TRANE
AIR CONDITIONING

SERVICE BULLETIN

No. **HCOM-SB-9**
DATE **2/6/76**
PRODUCT **RECIP. COMP.**
SERV. MAN. SECT. _____
PAGE **1-6**
T. GUTHRIE

SUBJECT: MODEL E COMPRESSOR, MECHANICAL FAILURES

FIGURE 1

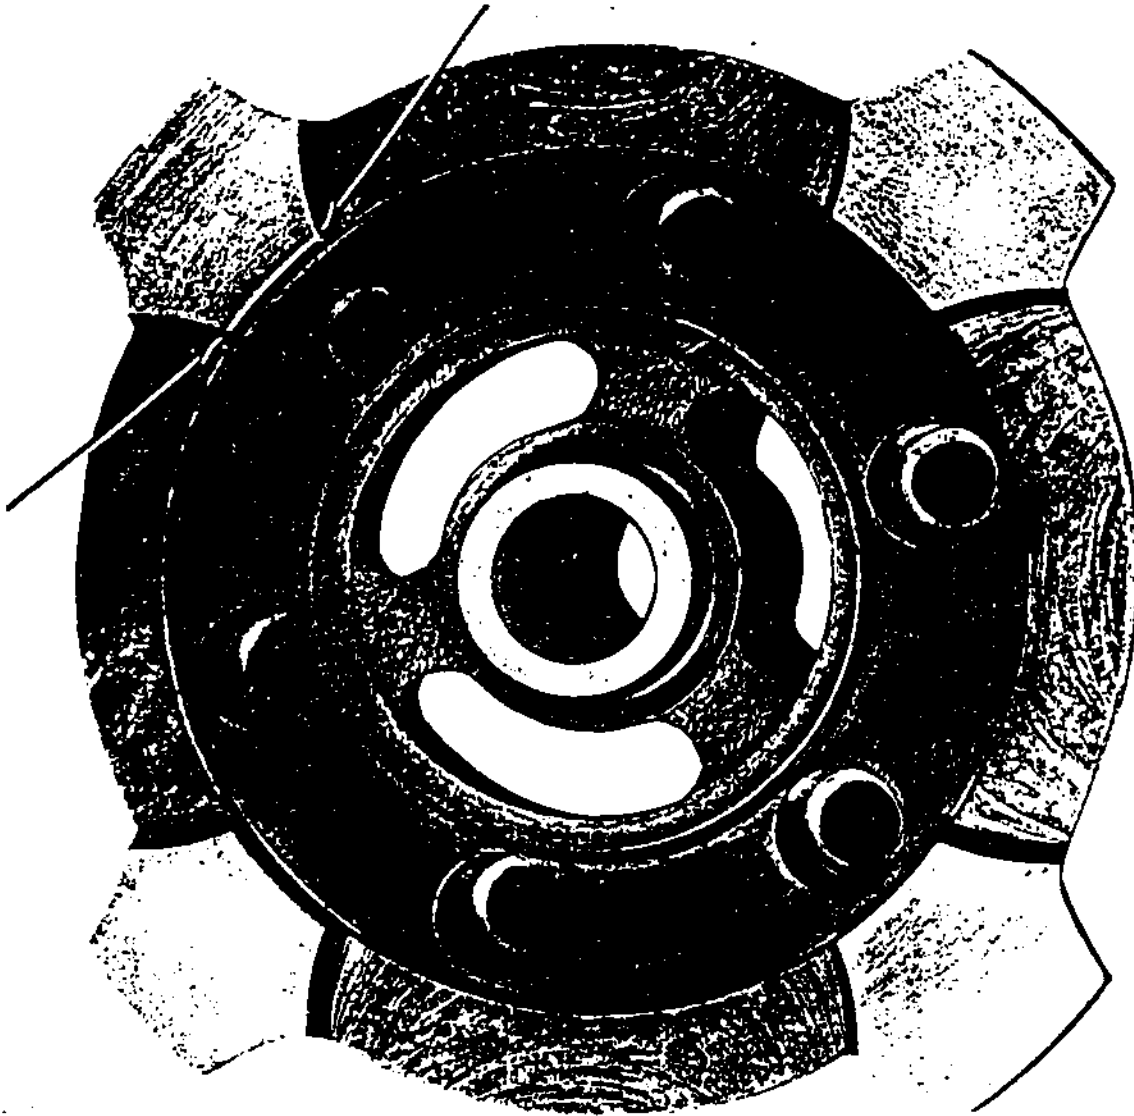
The reason for discharge valve hang-up is attributed to an incorrect or excessive chamfer on the valve operating counterbore. (See Figure 1). The chamfer should be approximately .005 to 0.010 inches deep. With this dimension the chamfer will appear as a very slight bevel.

If the chamfer is cut too deep, the discharge valve can move out of its operating counterbore and be caught between the discharge cage and suction valve plate, if the cage also lifts off the suction valve plate.

Check the chamfer on each of the discharge valve cage assemblies prior to installation. The chamfer should be cut at approximately .005 to .010 of an inch. A simple test may be used to determine whether or not the cage is usable. The valve should be depressed as far as possible on one side and then pushed sideways to see if the valve can be pushed out of its normal counterbore. Any cage found in which the valve may be displaced should not be used when rebuilding a compressor.

FIGURE 3 - New 3 1/2 Coil

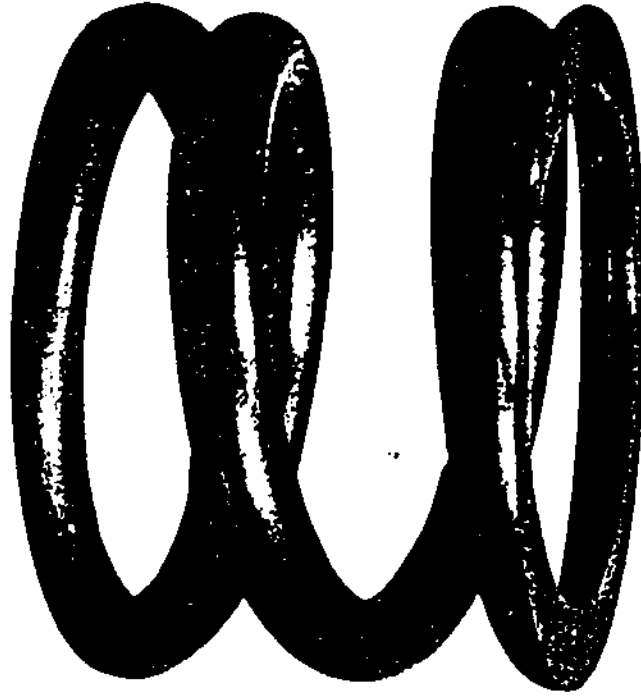
The cylinder head spring was changed in 1972 from three to three and one half total coils as shown in Figure 2 and 3. The wire material was also

changed to increase the maximum allowable stress in the spring.

Reinstallation of a short spring during overhaul may allow the discharge cage assembly to lift during normal operation because of insufficient spring compression. The cage movement coupled with the possibility of the discharge valve moving sideways from its normal position will prevent the valve from seating thus allowing continuous hot gas leakage to the top of the piston. When this occurs, alternate loading of the bearings is interrupted which can cause an eventual compressor failure.

If the old style cylinder head spring (see Figure 2) is being reused for overhaul, check to see that the spring has not taken a set. Place the spring on a flat surface and lay a straight edge on the top of the spring. Rotate the spring 360° to determine the minimum free length. Minimum free length for a reusable head spring is 2.47 inches.

FIGURE 4 - Cylinder Spring Installed Correctly

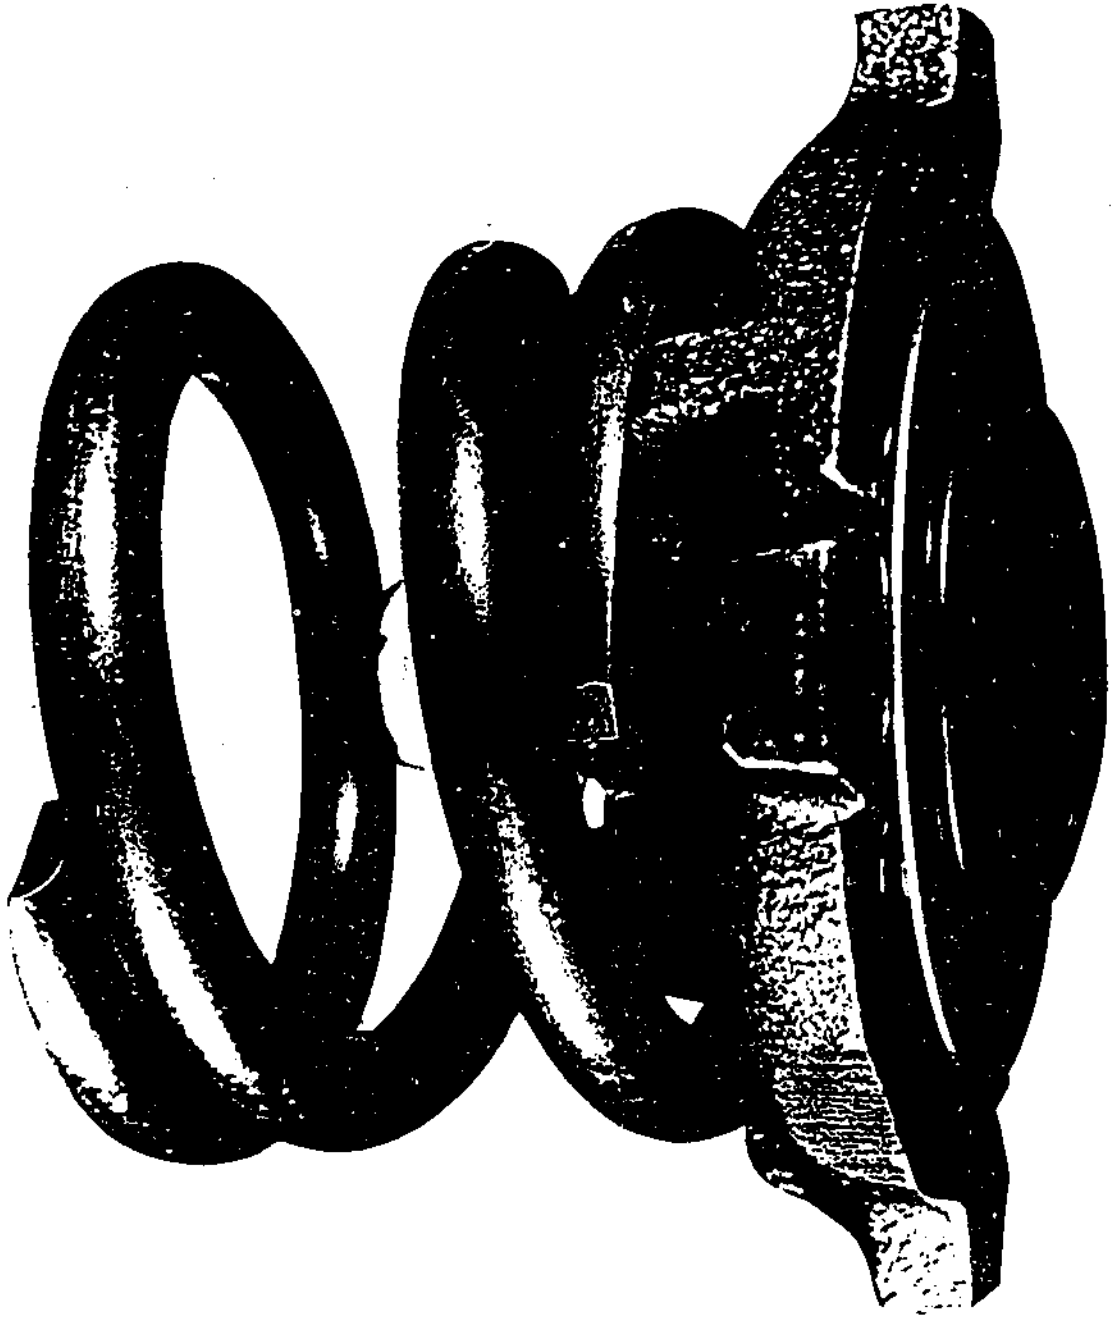
When reinstalling either style spring it is possible to improperly position the spring as described in Section 2 above. Be sure the start of the spring, when placed on the cage assembly, is located as shown in Figure 4.

FIGURE 5 - Cylinder Ring Installed Incorrectly

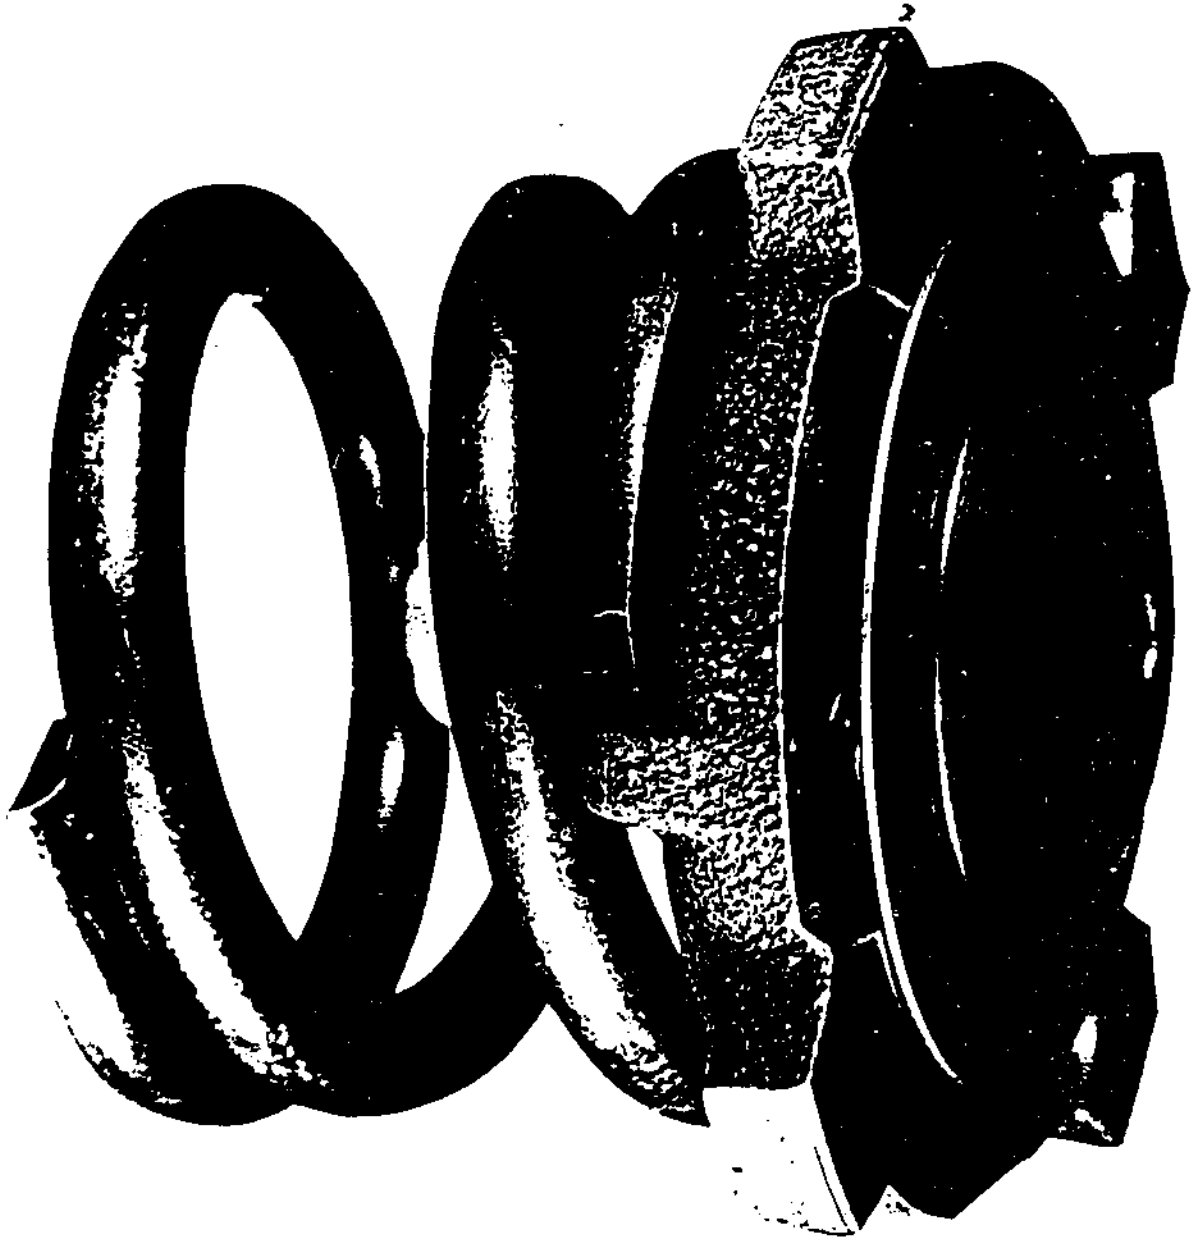
Improper spring positioning can occur when using either style cylinder head spring (three coil turns vs three and 1/2 turns) and positioning the start of the spring on a supporting rib on the discharge cage assembly as shown in Figure 5.

Improper spring position can allow movement (tilting) of the discharge cage assembly, resulting in excessive noise, probable discharge valve seating problems, and potential mechanical failures.
